City of Carlisle, Iowa
Planning and Zoning Commission
Regular Meeting
October 19, 2020
7:00 P.M.
Carlisle City Hall

RE: **Summertime Potato Company – Preliminary Plat & Site Plan**

FOX Ref No: 8666-20B.240

Thank you for submitting your project for review. The City is committed to assisting you with the completion of this project. FOX Engineering and the City Staff have completed the second review for the Summertime Potato Preliminary Plat & Site Plan dated October 12, 2020 and have the following comments:

DATE: Oct. 12, 2020
 3RD SUB. Oct 12, 2020
 2ND SUB. Oct 12, 2020
 1ST SUB. SEP. 24, 2020
 DATE OF SURVEY: AUG. 28, 2020
 DESIGNED BY: JAG
 DRAWN BY: JAG

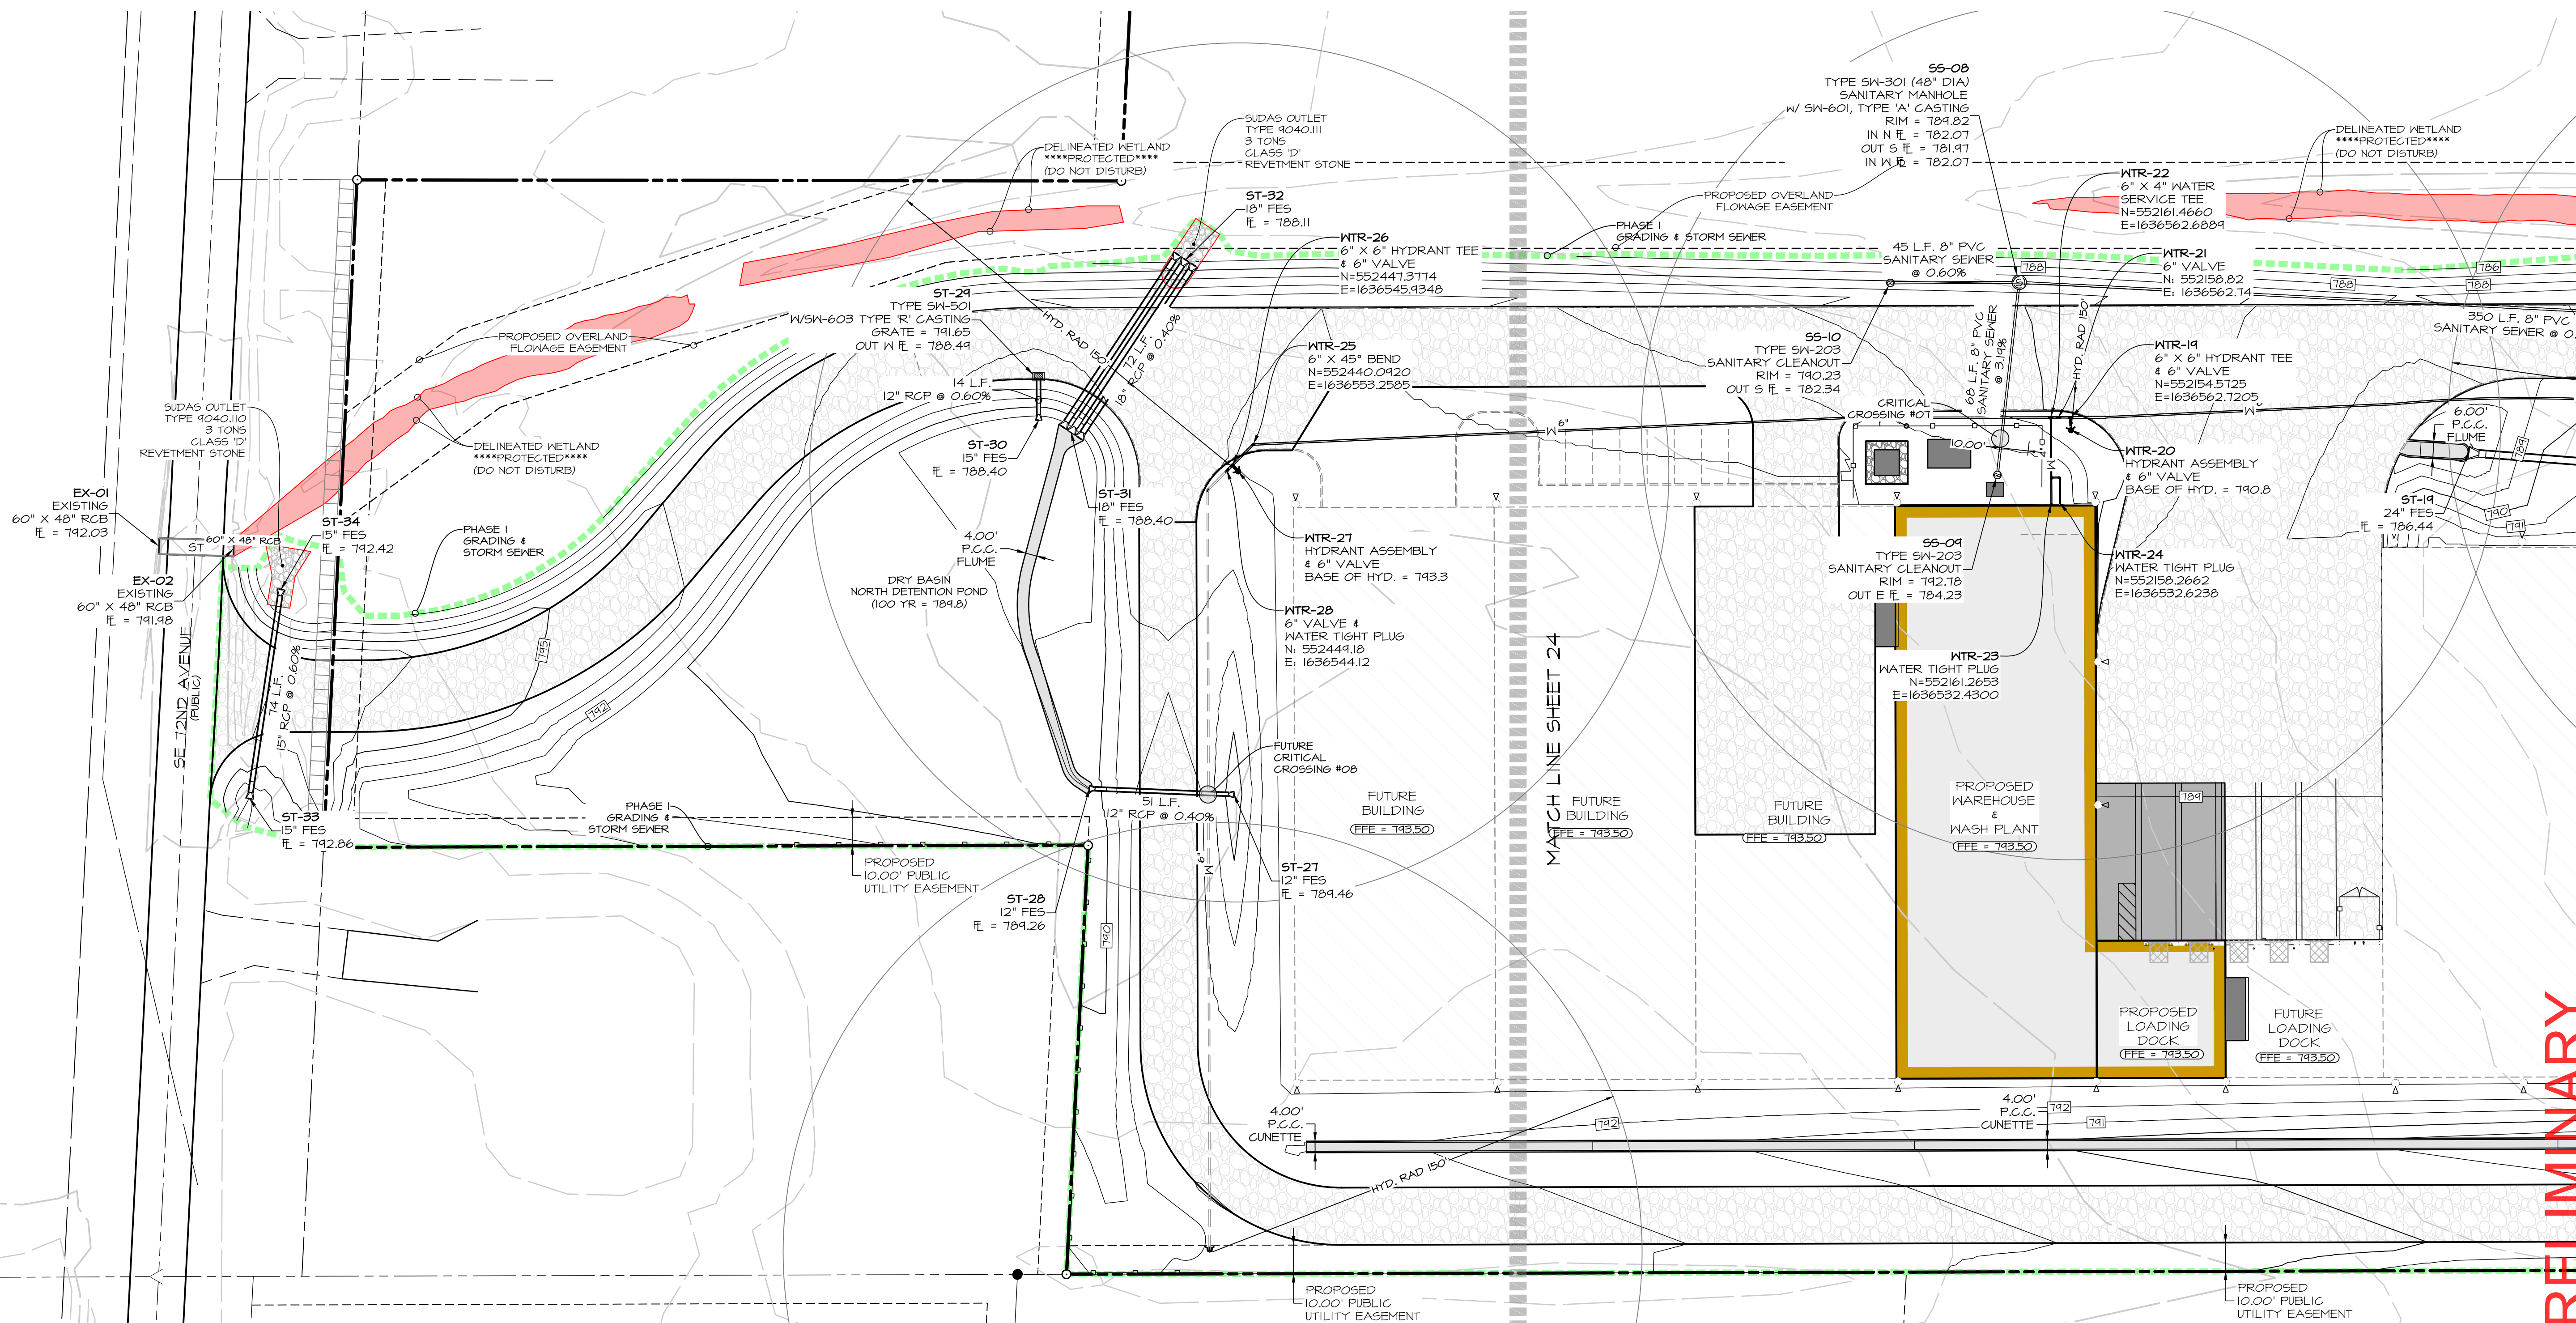
22. We understand that the site may require a sand/oil separator due to the amounts of soil that may enter the sanitary sewer waste system. This should be determined prior to construction after discussion with the wash plant manufacturer.
23. Please show the location of the post indicator valve on the utility sheets.
24. Please provide 225' radii for the hydrants along the east access. It appears that the hydrant near the NW corner of the Goodhue property could be moved westerly to provide more spacing.
25. Please dimension the erosion control placement throughout the site plan.

CARLISLE VET CLINIC
DIMENSION PLAN
SNYDER & ASSOCIATES, INC.

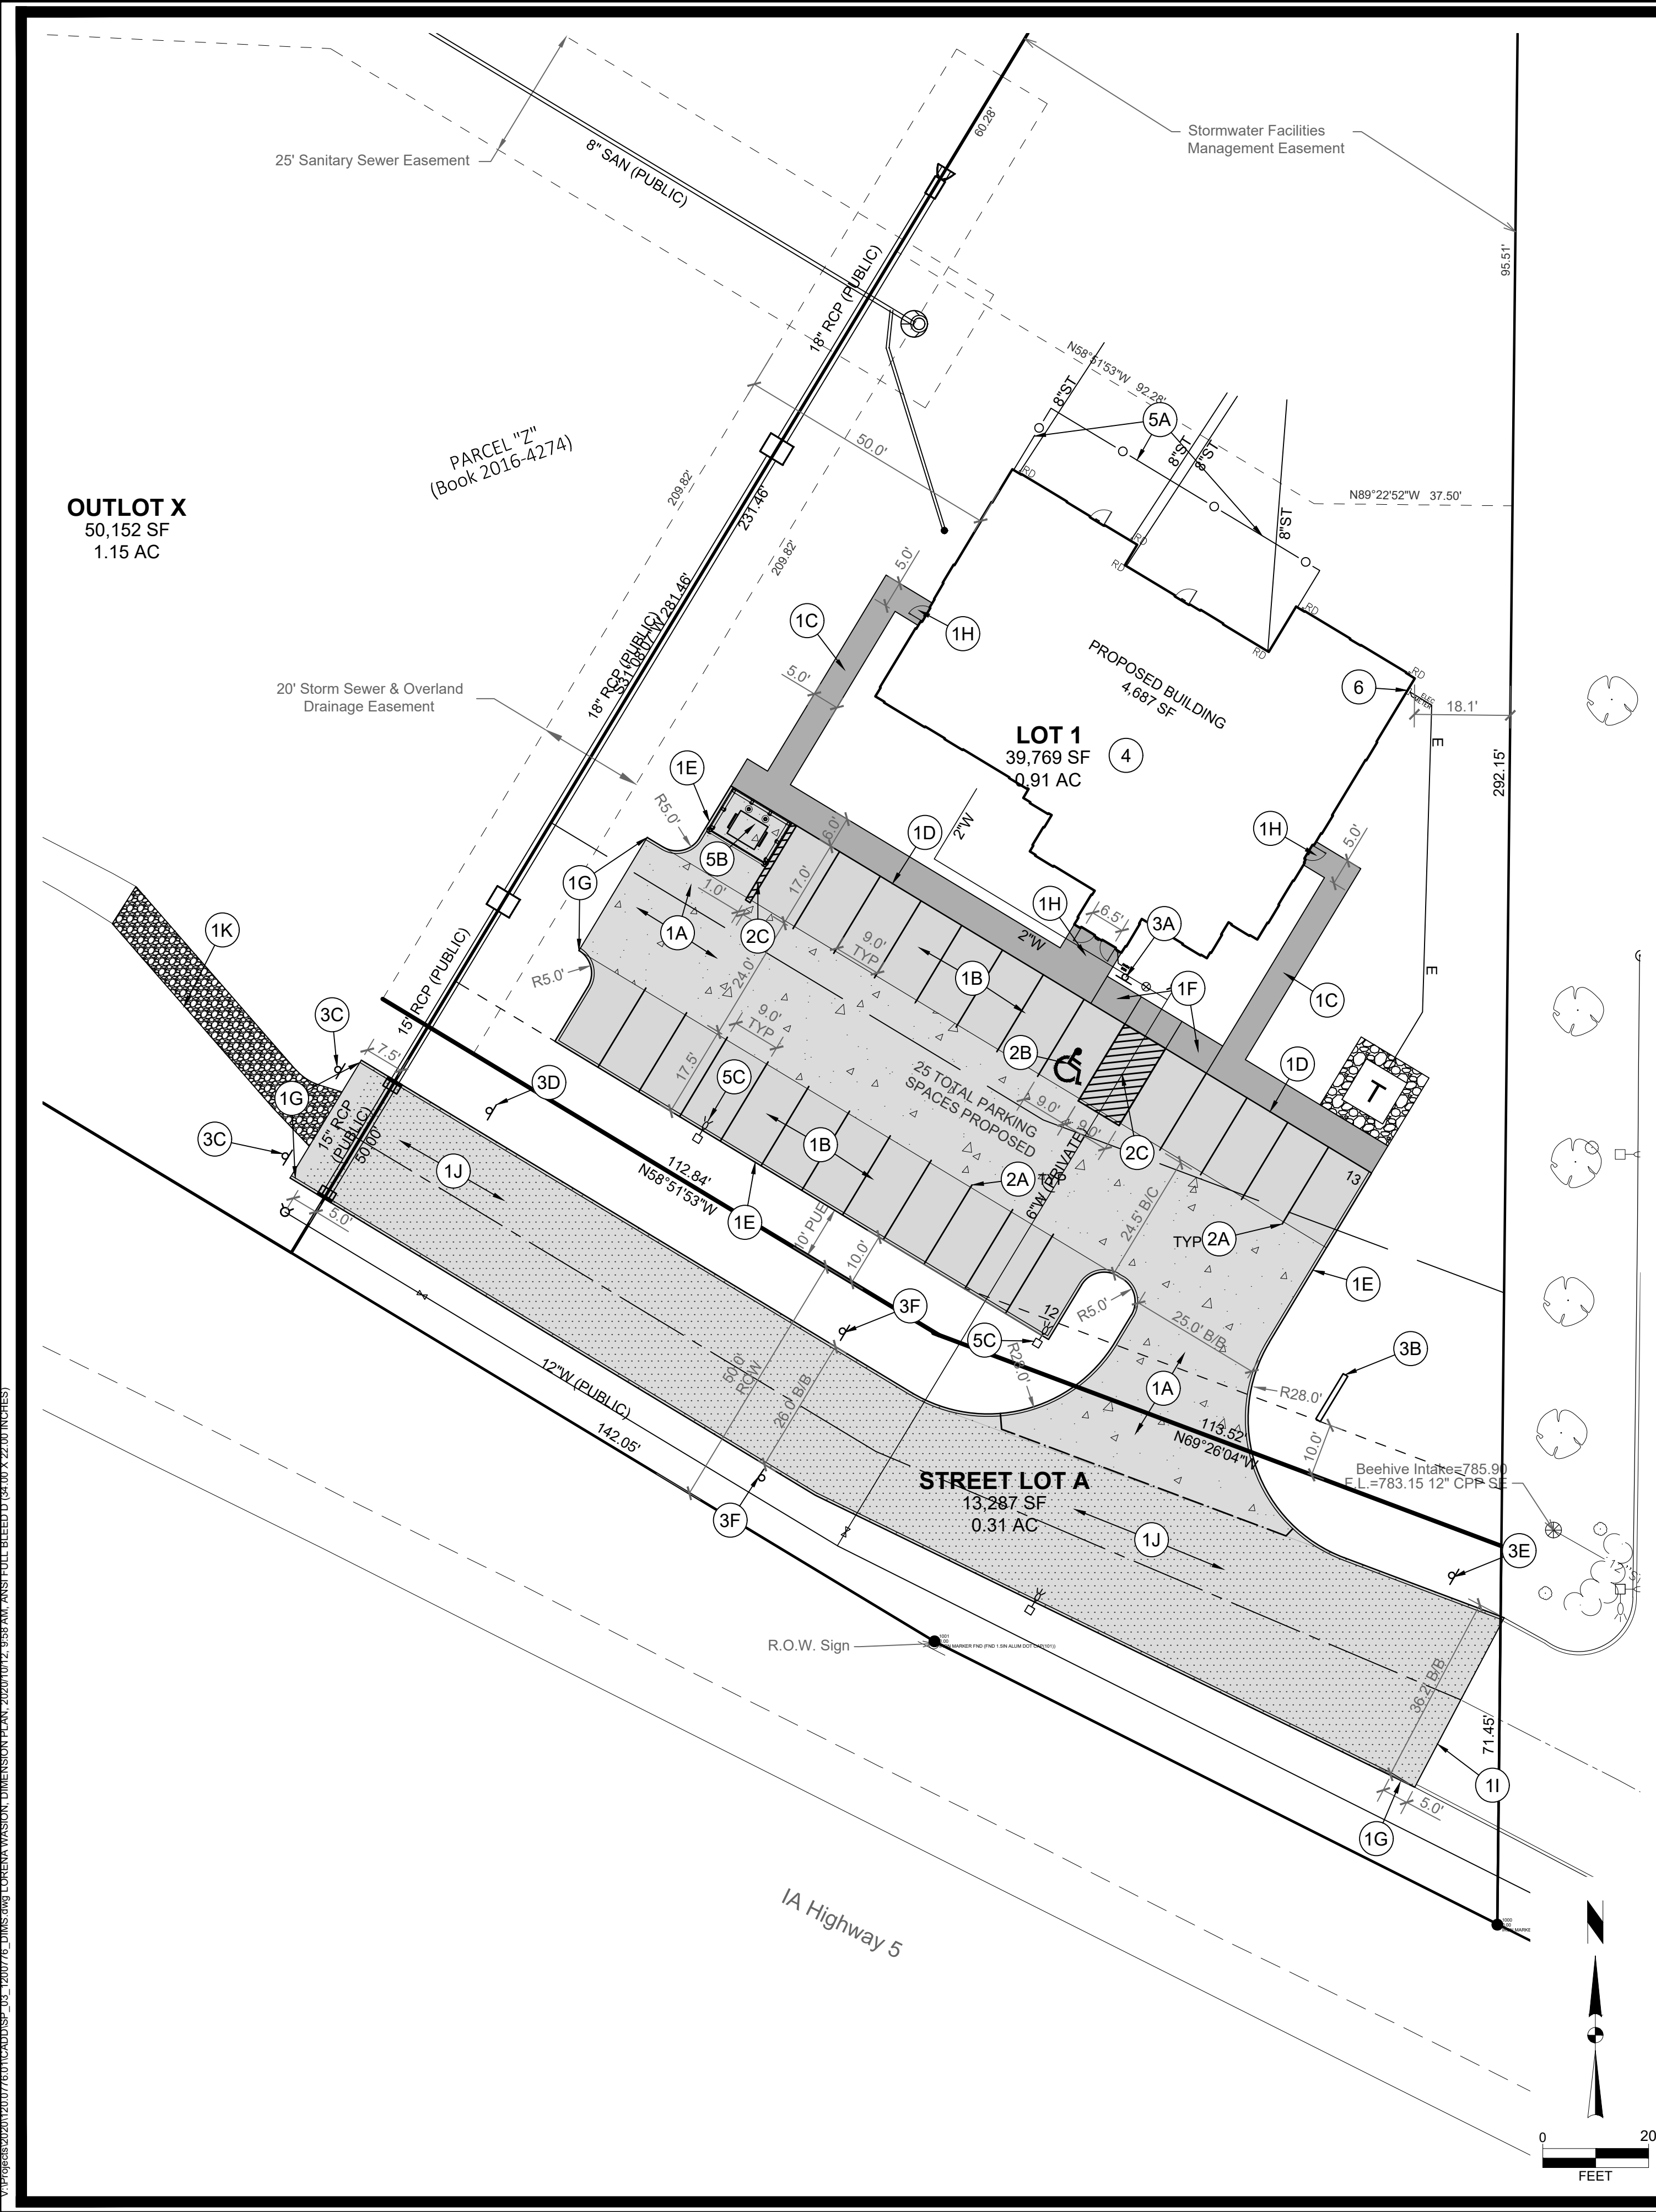
6. It appears that the public roadway dead-end is longer than 150-ft without a turnaround which is not allowed per the International Fire Code (Appendix D, D103.4). Please provide a proper turnaround at the end of the public street as per IFC Table D103.4 and Figure D103.1. The turnaround may be gravel. Please provide a cross section of the surfacing of the turnaround.
